SITE DESIGN

APPROVED DRAWINGS FROM DRB PACKAGE DATED 2020.02.09

PROPOSED DESIGN

VAIL TOWN PLANNING AND ENVIRONMENTAL AGENDA MEMO

2 SITE PLAN DIAGRAM
1" = 20'-0"

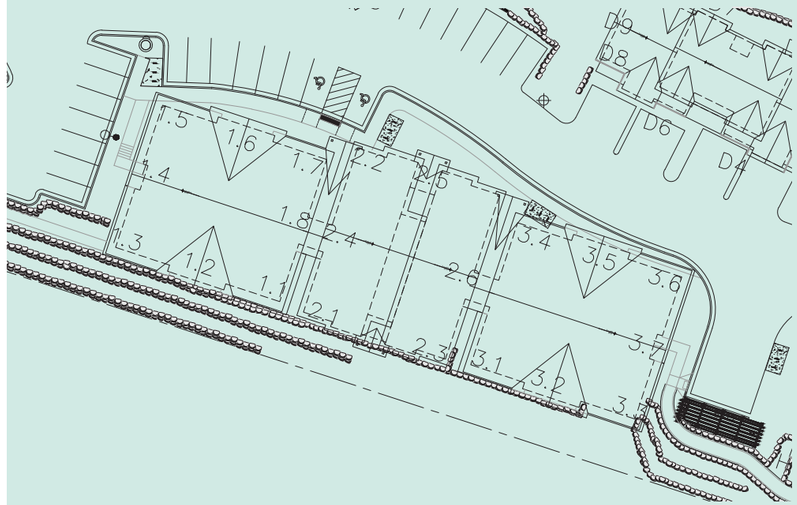
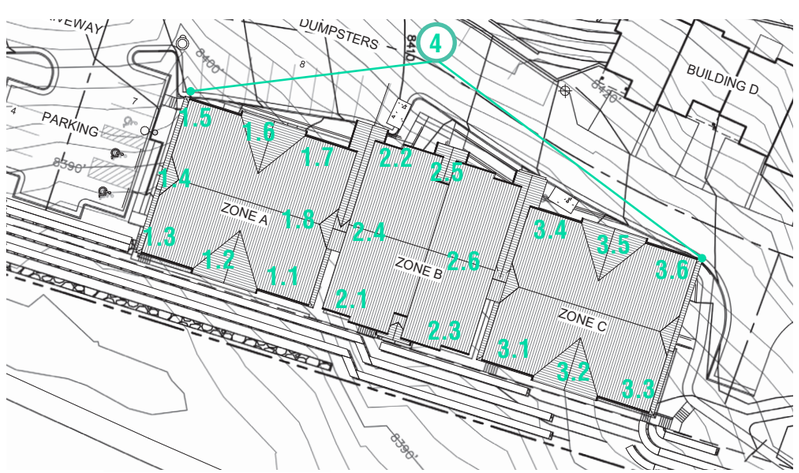
3 Shift alignment of the access road approximately 6'-0" to the north to meet ADA and TOV requirements (prior floor plans and site plans were not coordinated and did not accommodate for road placement).

4 Adjust grading and roof form to meet requirements of a 3-story building with basement, as designed in original approval.

5 Adjust sidewalk layout to provide conforming accessible routes throughout per TOV requirements.

6 Adjust rock walls to limit height to 3'-0" and less than 2'-0 from the front setback per TOV requirements.

7 Coordinate Civil and Architectural to accurately represent proposed apartment building floor plan (prior floor plans and site plans were not coordinated and did not accommodate for road placement).

8 Coordinate Civil and Architectural to accurately represent proposed townhome floor plan (prior floor plans and site plans were not coordinated and did not accommodate for road placement).

9 Adjust rock fall wall design to a balanced cut and fill rather than entirely fill and soften transition at rear of Townhomes. This will result in less construction traffic and project impact.

10 Update rear Townhome site work to minimize overlot grading and preserve existing vegegation.

13 Increase accessible parking to meet Code and relocate to achieve required accessible route per TOV requirements.

14 Adjust underground utilities to conform to Eagle River Water and Sanitation District standards.

1 **BUILDINGS 1/2/3 - WEST ELEVATION**
1/8" = 1'-0"

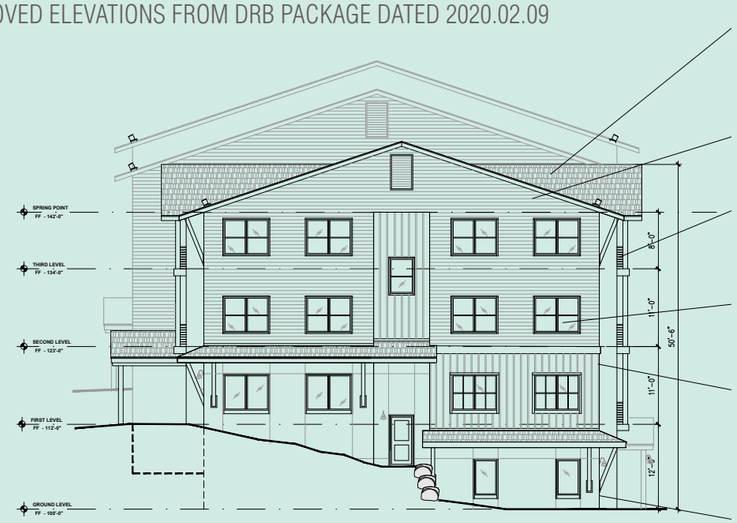
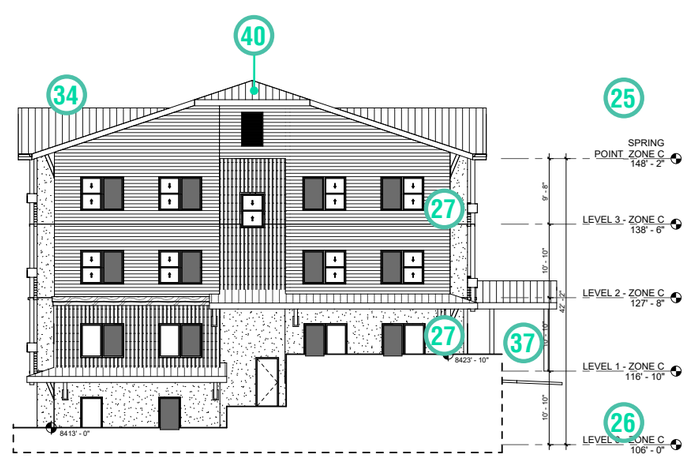
Overall building layout and exterior grading is revised to support the position of a code-compliant 3-Story building with a basement, to provide compliant handicap access and adequate exiting.

If we had followed the horizontal controls from the previous DRB submittal that would have resulted in the project being classified per IBC guidelines as a 4-Story building. The previous layout did not provide adequate exiting from all occupied areas, or code-required accessible routes. Solar panels were also included to conform to the DRB conditions of approval dated 2020.03.04.

24 Coordinate elevation changes between Zones A-B and B-C to lower Average Grade Plane to facilitate required Accessible Routes for the project per TOV requirements.

25 Increase elevation of Spring Points at roof level by 1' - 8" to meet Code requirements for finished ceiling heights on top floors to achieve code minimums.

26 Reduce Floor-to-Floor heights at all levels to offset the increase in Spring Points at the roof level as noted above.

27 Reduce angle of kickers at low roof overhangs to comply with code compliance and clearances below; changed kicker angle at high roofs to match and meet code requirements.

28 Slot window elevation changed to accommodate the elevation of the low entry roofs.

34 Change roof material from asphalt shingles to standing seam metal per DRB conditions of approval dated 2020.03.04.

37 Building entry point design updated per DRB conditions of approval dated 2020.03.04.

40 Adjust roof form meet approved building heights.

1 ROOF PLAN
1/8" = 1'-0"

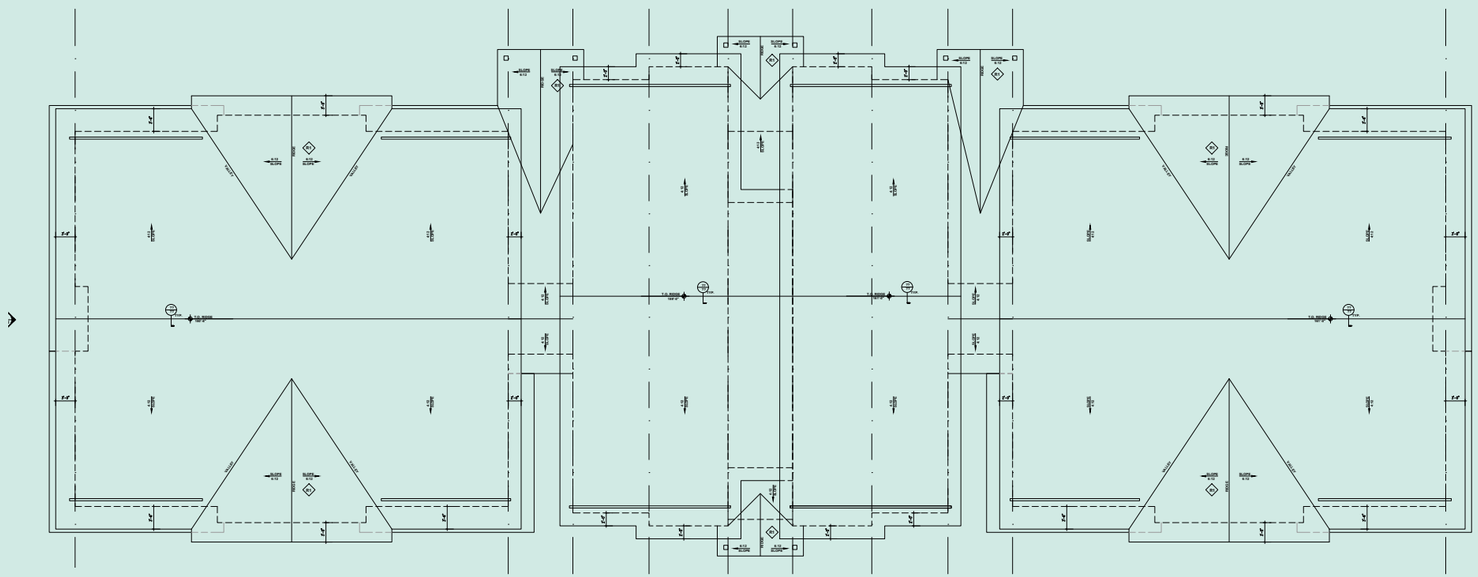
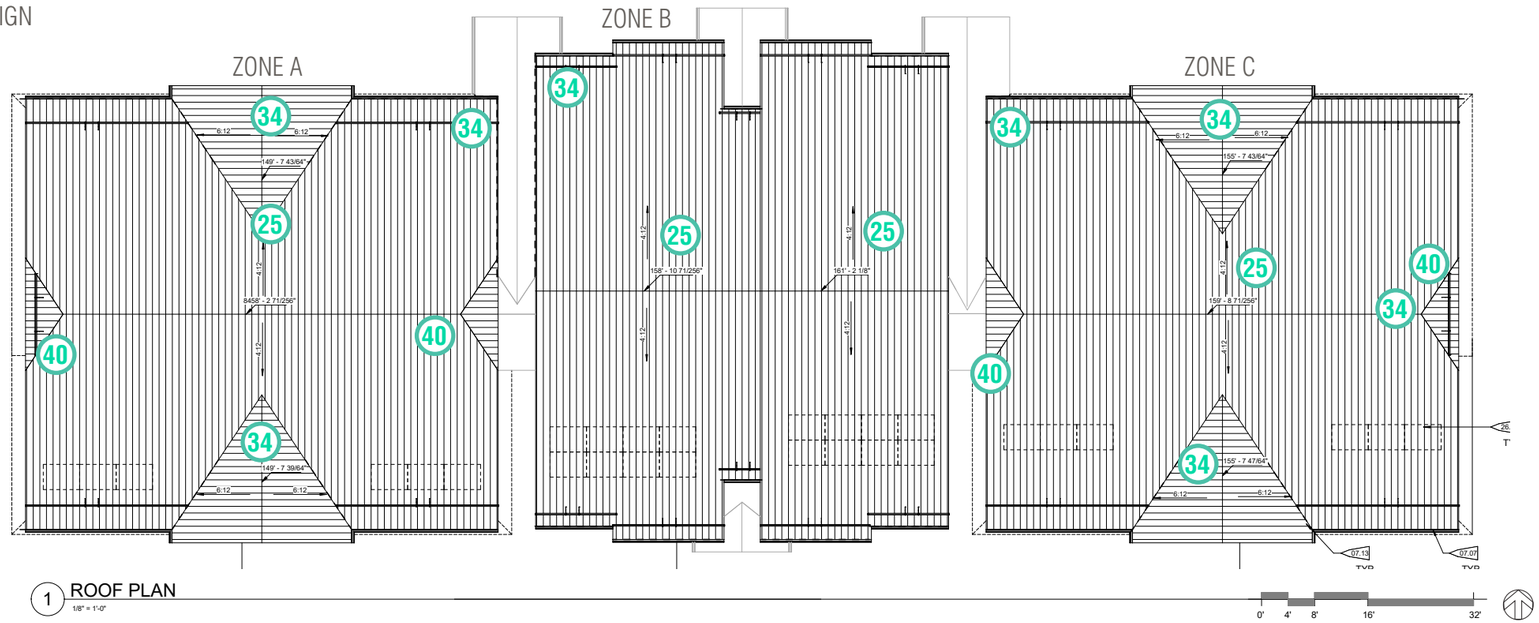
25 Change Building Height call-outs to be accurate. Previously approved roof plans and elevation callouts were not coordinated.

34 Change roofing material from asphalt shingles to standing seam metal and update corresponding dormer locations per DRB conditions of approval dated 2020.03.04.

NOTE: material change to standing seam applies to both high and low roofs.

40 Adjust roof form meet approved building heights.

1 LEVEL 0 FLOOR PLAN - OVERALL
1/8" = 1'-0"

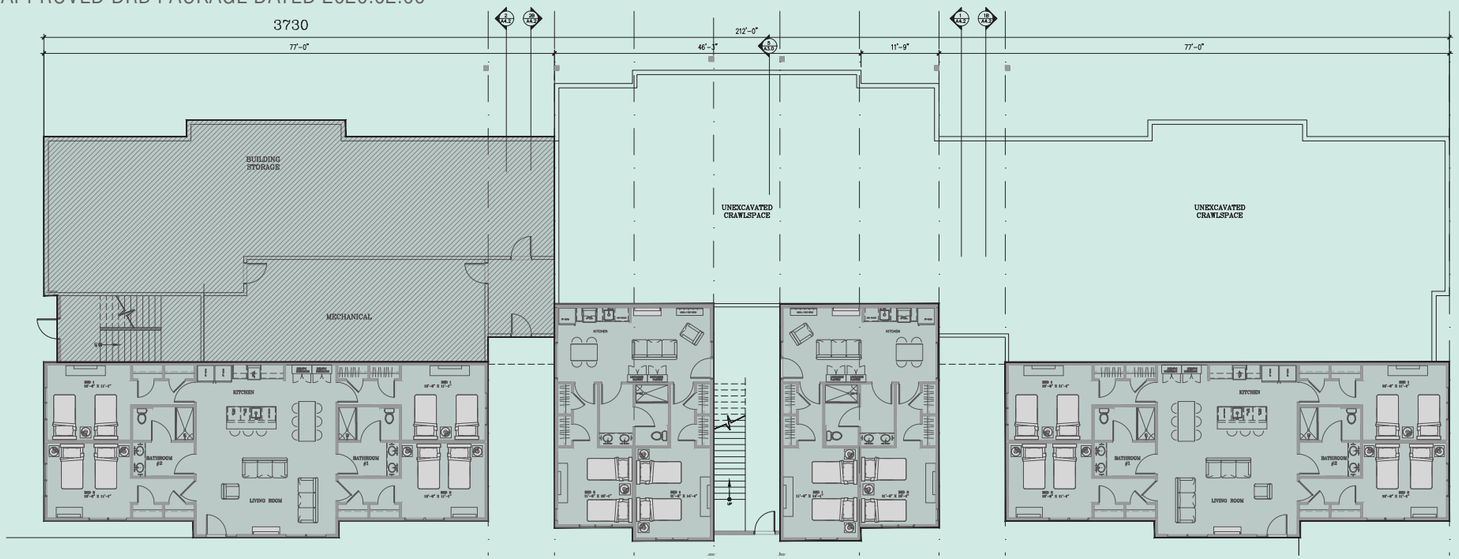
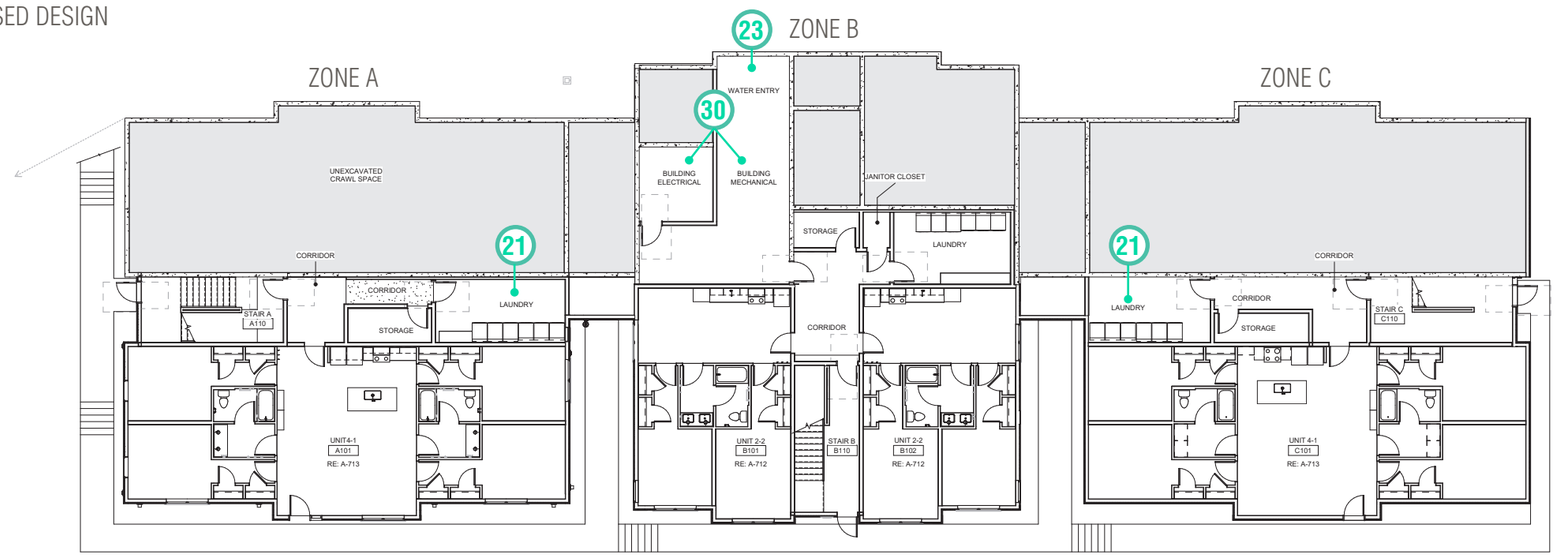
Trash service rooms were added as the previous design did not provide an accessible path to the trash enclosure. Laundry rooms were added. A water entry room was added as this is required by the fire code.

20 Add Trash Collection room(s) on accessible route.

21 Add Laundry room(s) on accessible route.

22 Add Property Manager's Office on accessible route.

23 Add dedicated Water Entry room at Level 0.

30 Relocate Mechanical and Electrical rooms.

1 LEVEL 1 FLOOR PLAN - OVERALL
1/8" = 1'-0"

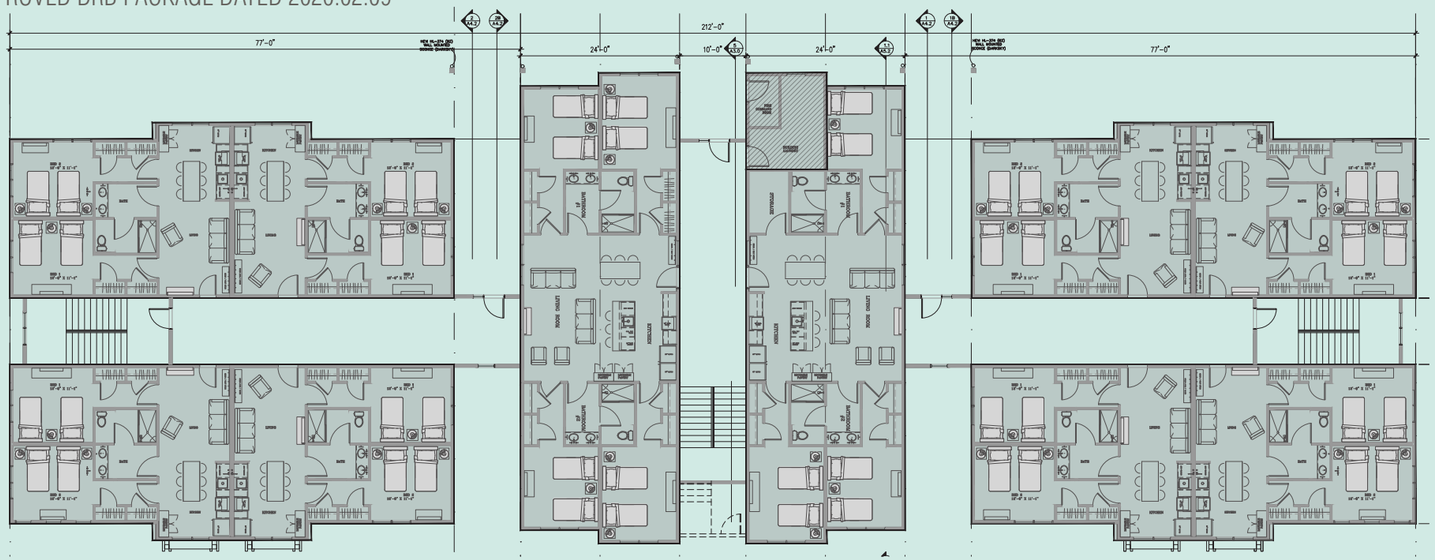
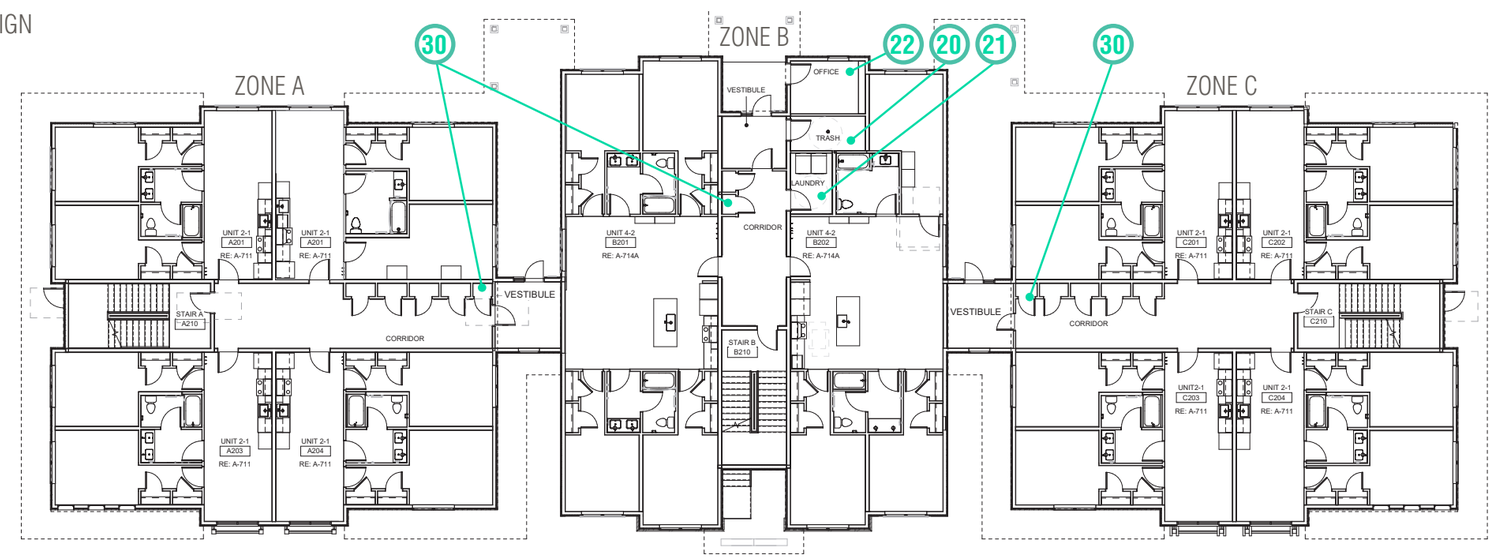
Trash service rooms were added as the previous design did not provide an accessible path to the trash enclosure. Laundry rooms were added. A water entry room was added as this is required by the fire code.

20 **Add Trash Collection room(s) on accessible route.**

21 **Add Laundry room(s) on accessible route.**

22 **Add Property Manager's Office on accessible route.**

23 **Add dedicated Water Entry room at Level 0.**

30 **Relocate Mechanical and Electrical rooms.**

1 LEVEL 2 FLOOR PLAN - OVERALL
1/8" = 1'-0"

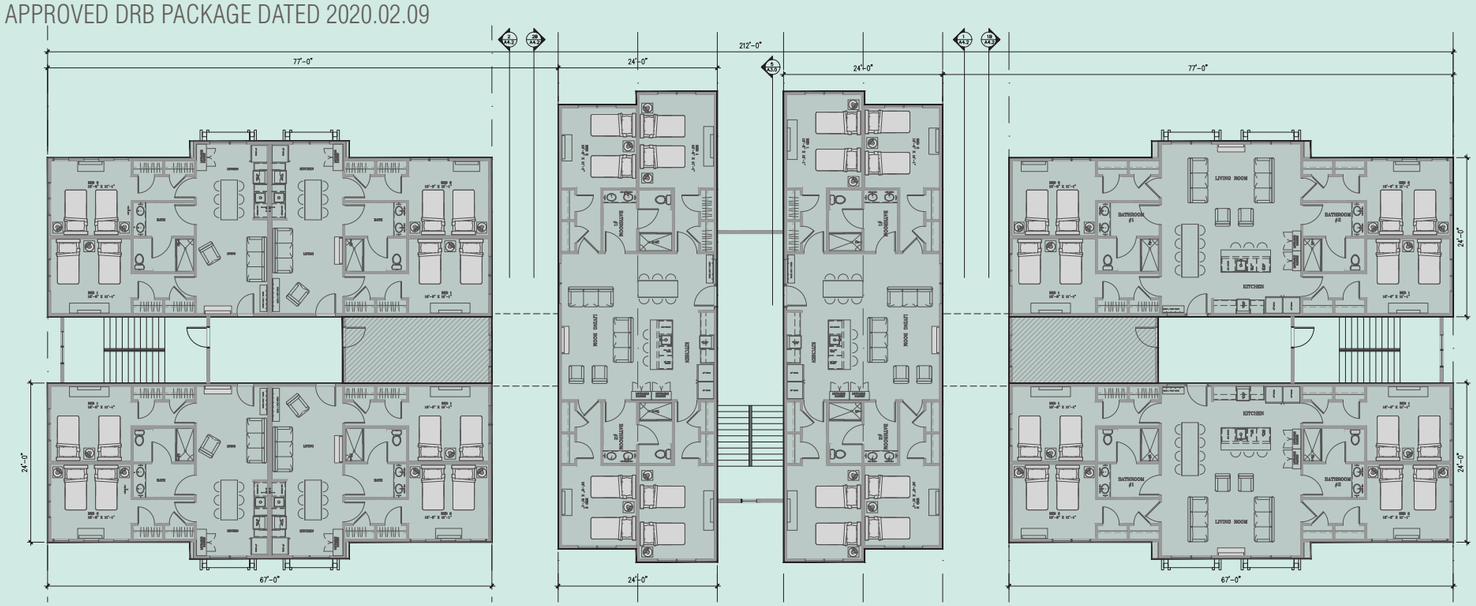
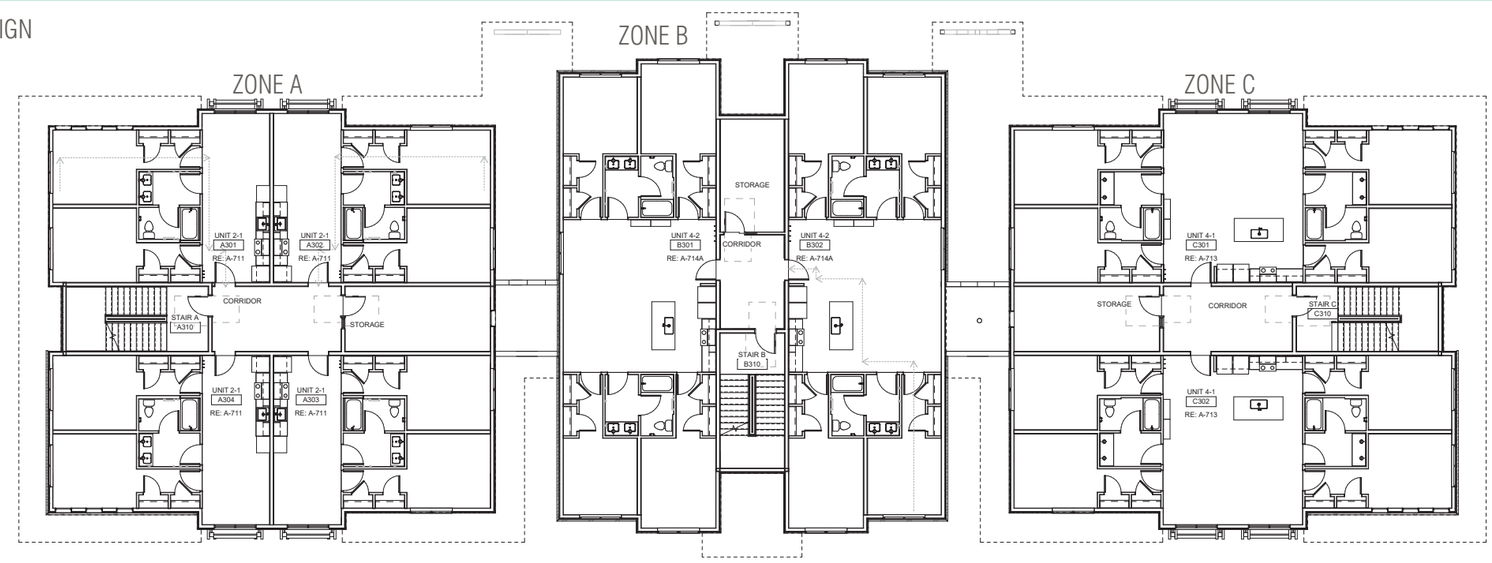
Trash service rooms were added as the previous design did not provide an accessible path to the trash enclosure. Laundry rooms were added. A water entry room was added as this is required by the fire code.

20 Add Trash Collection room(s) on accessible route.

21 Add Laundry room(s) on accessible route.

22 Add Property Manager's Office on accessible route.

23 Add dedicated Water Entry room at Level 0.

30 Relocate Mechanical and Electrical rooms.

1 LEVEL 3 FLOOR PLAN - OVERALL
1/8" = 1'-0"

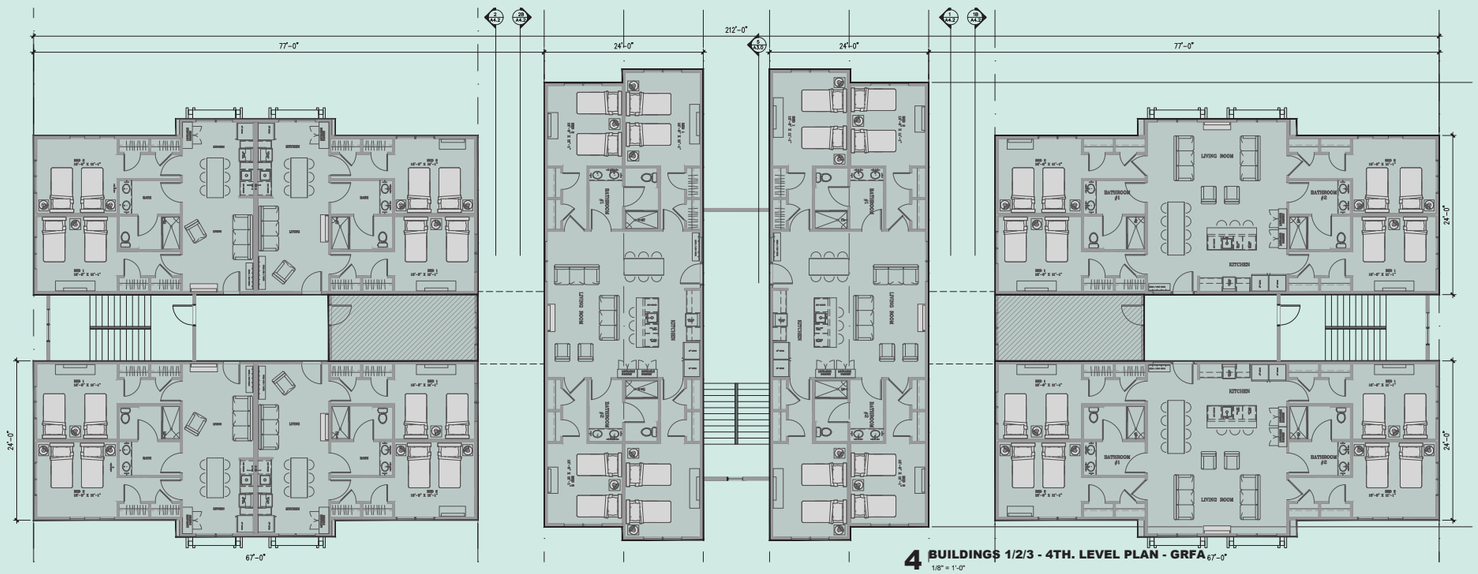
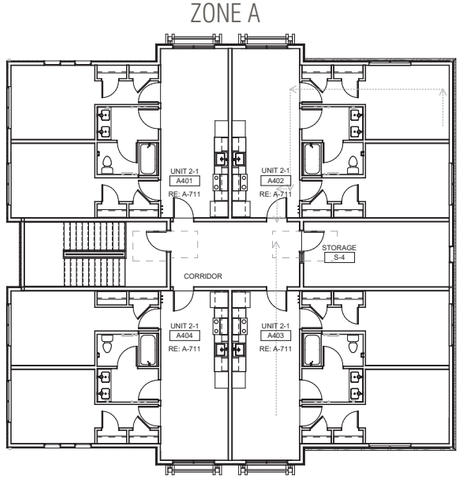
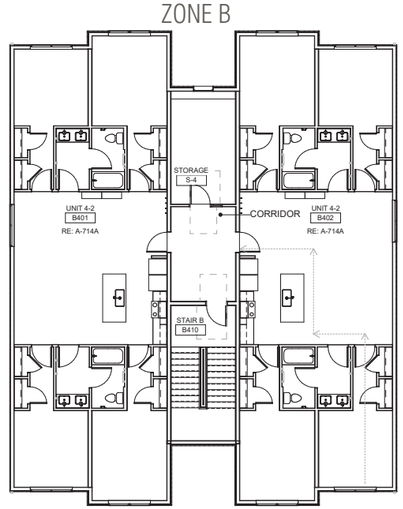
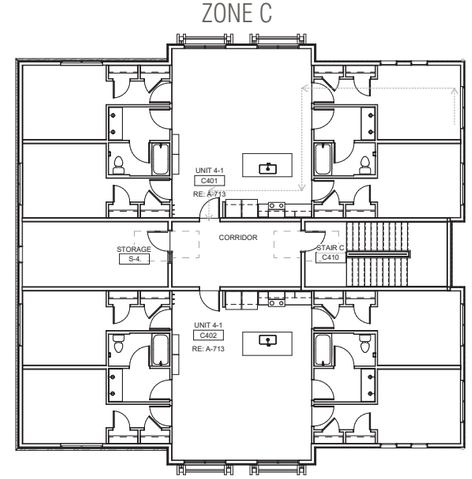
Trash service rooms were added as the previous design did not provide an accessible path to the trash enclosure. Laundry rooms were added. A water entry room was added as this is required by the fire code.

- **20 Add Trash Collection room(s) on accessible route.**
- **21 Add Laundry room(s) on accessible route.**
- **22 Add Property Manager's Office on accessible route.**
- **23 Add dedicated Water Entry room at Level 0.**
- **30 Relocate Mechanical and Electrical rooms.**
